Objections to and comments on CDM credits for
Mangdechu hydropower project in Bhutan
and export of hydropower from it to India
by Mangdechhu Hydroelectric Project Authority

We hereby strongly oppose the granting of CDM credits to Mangdechhu Hydroelectric Project Authority (MHPA) for the 720 MW Mangdechhu hydro power project in Bhutan for the following amongst other reasons.

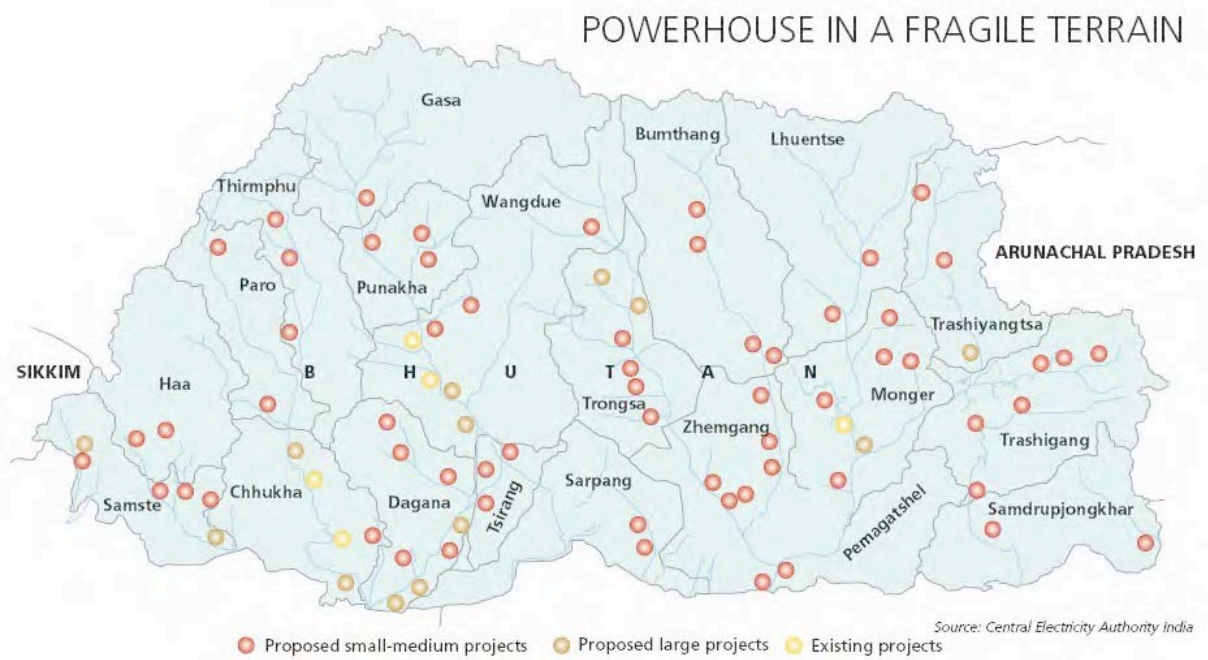
- 11) Some of the other issues with respect to forests, ecology and environment are:
 - a) The reservoir submerges dense forests which are home to a resident population of the endangered golden langur.
 - b) Development of dams in Bhutan largely follows the Indian model which has many issues and problems and has scant regard for the environment. Common problems include muck dumping in the riverbed and on forested hill slopes,

inadequate release of minimum flows from dams, no monitoring of flows released, etc. Photographs of muck dumping by this project are enclosed.
